Service Bulletin

Bulletin No. 2005-66
CMD 2005-06

2.8L Sea Water Drain Plug Location

Model	Serial Number
2.8 EI	88010500 and above that use publication 90-865861041

Figure 1

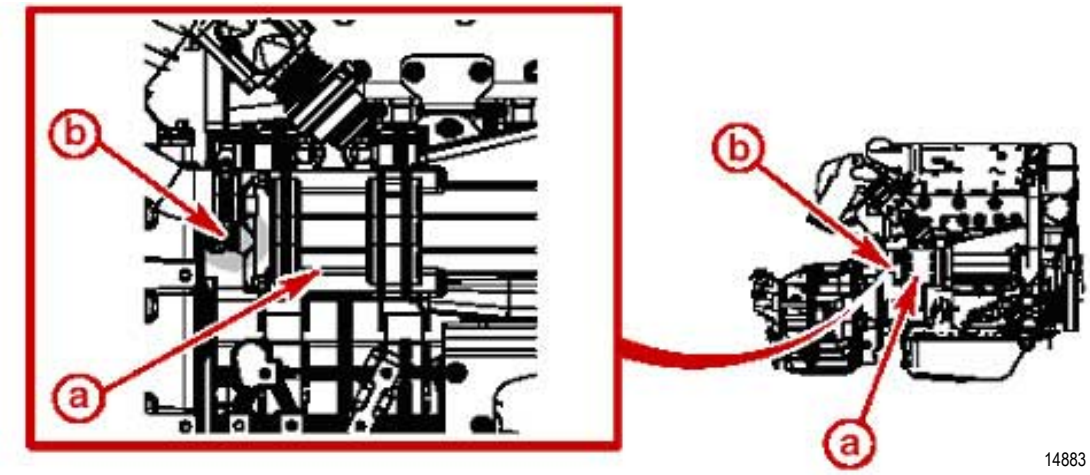
The Owners manual PN# 90-865861041 for the inboard version of the above engines has incorrect data on page 81. The call out location for the plug to drain the sea water from the heat exchanger incorrectly points to the freshwater coolant drain plug. Removing this plug will result in the loss of engine coolant.

The correct location for draining the sea water from the heat exchanger and transmission cooler is located on the rear of the transmission cooler (refer to figure 1). Owners manual PN# 90-865861041 has been updated with the correct information and is re-issued under part number 90-865861050.
